## WOKINGHAM TOWN COUNCIL COMMENTS ON 161839 BELL FARM

***Easterly wind direction, speed and hours rose chart***

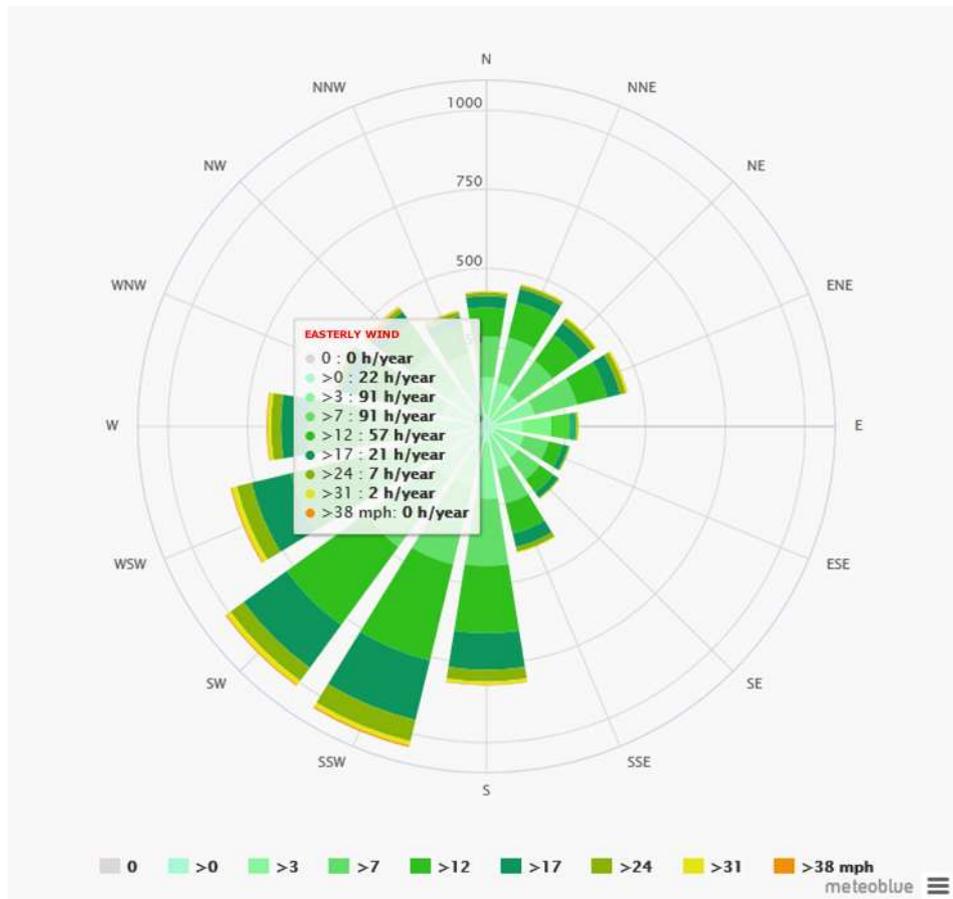
WTC feel that the wind direction blowing from the East for 296 hours and from the East North East for 419 hours per year, as shown in the two wind roses below, the current and reduced levels of odour emissions, with a 3 ouE/m3 odour plume as shown on page 25 Figure 4: “Dispersion model output for operations following completion of upgrade works”, having a moderately offensive smell rating from the chart on page 11, would be an unacceptable loss of amenity due to the unpleasant odour emitted from the sewage works passing over the development.

**Figure 8: Façade noise level predictions (1.5 metre noise map)**

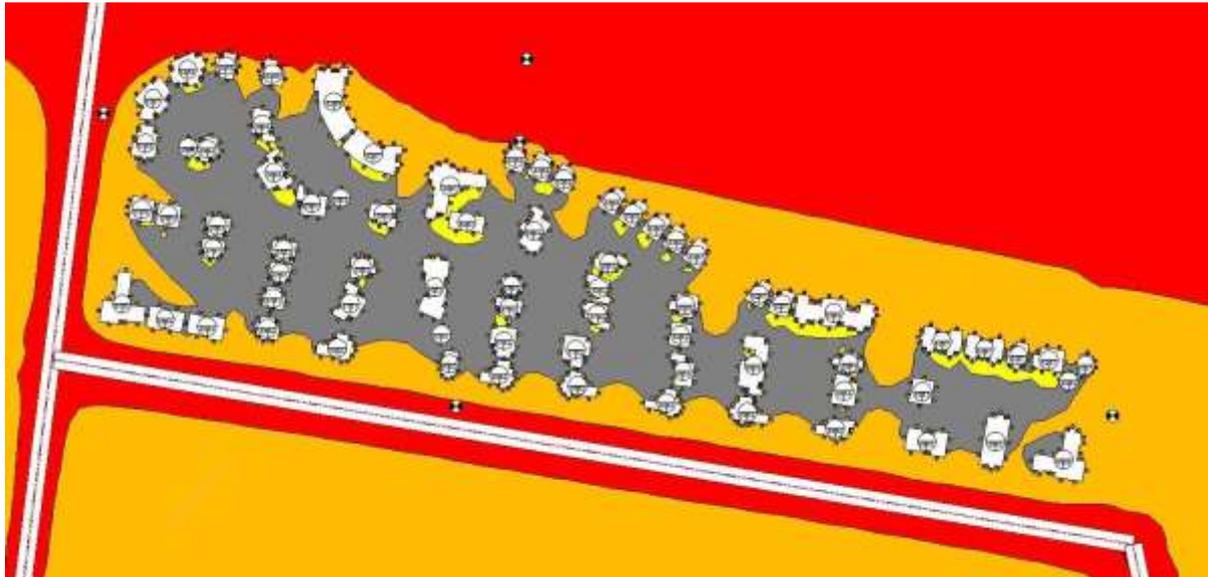
WTC would like to respectfully point out that Bell Foundry Lane is to be an integral part of the Northern Distributor Road and thus it will have a vastly increased traffic flow once completed. We note that this has not been included in the calculations for noise assessment of the development and the impact on the amenities of the dwellings adjacent to the road.

Figure 8 on page 14, shows the expected noise levels at 1.5 metres representative of garden and amenity areas for the dwellings. The levels are expected to be below the WHO guidance level of 55 dB LAeq, 16 hour however the increased traffic flow along the NDR will take the levels above this.
